Access Compliance Report

Public Rights-of-Way

Intersection ID: 20109	Main Street: COLUMBINE_CR	Cross Street: COLUMBINE_CT	Location: NW
ADA ID: C13E90DD0A08	Ramp Type: PerpDiag	Initial Pass/Fail: Fail	Overall Compliance: No
Severity Score: 13.75			
Codes/Mitigation Info/Possible Solution		Field Measurements/Component Compliance

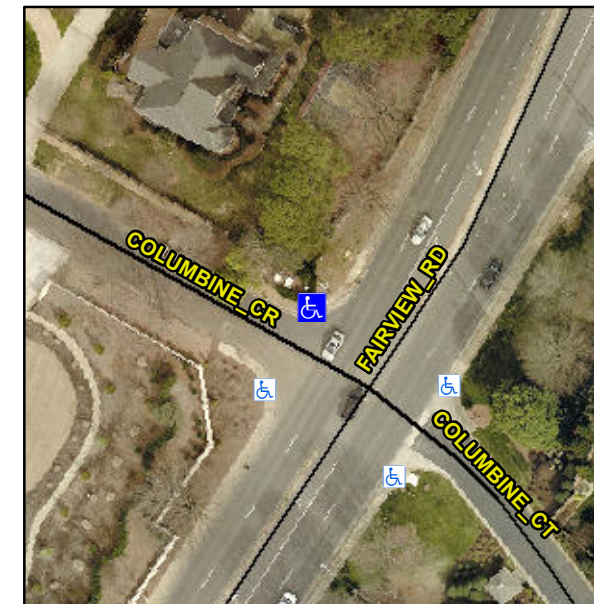
Not Found, R304.2.2, R304.5.3

Compliance	Description	Data	Compliance	Description	Data
N/A	Ramp Length (in)	57.0	No	Ramp Slope (%)	8.7
Yes	Ramp Width (in)	48.0	No	Ramp XSlope (%)	3.0
N/A	Flare Type LT	N/A	N/A	Flare Type RT	N/A
N/A	Flare Slope LT (%)	N/A	N/A	Flare Slope RT (%)	N/A
N/A	Flare Traversable LT?	N/A	N/A	Flare Traversable RT?	N/A
N/A	Landing Length (in)	N/A	N/A	DWS Provided?	N/A
N/A	Landing Width (in)	N/A	N/A	DWS Contrast?	N/A
N/A	Landing Slope (%)	N/A	N/A	DWS Length (in)	N/A
N/A	Landing X Slope (%)	N/A	N/A	DWS Full Width?	N/A
N/A	Landing Curb? (Y/N)	N/A	N/A	DWS Offset (in)	N/A
N/A	Shared Landing?	N/A			
N/A	Gutter Ponding?	N/A	N/A	Gutter Slope (%)	N/A
N/A	Gutter Lip Ht (in)	N/A	N/A	Gutter X Slope (%)	N/A
N/A	Painted X Walk1?	No	N/A	Painted X Walk2?	No
	X Walk 1 Direction	To SW		X Walk 2 Direction	To SE
N/A	X Walk 1 Width (in)	N/A	N/A	X Walk 2 Width (in)	N/A
	X Walk 1 Slope (%)	0.6		X Walk 2 Slope (%)	4.2
	X Walk 1 X Slope (%)	4.8		X Walk 2 X Slope (%)	2.4

Remove & Replace Curb Ramp With Two New Directional Ramps or Equivalent.
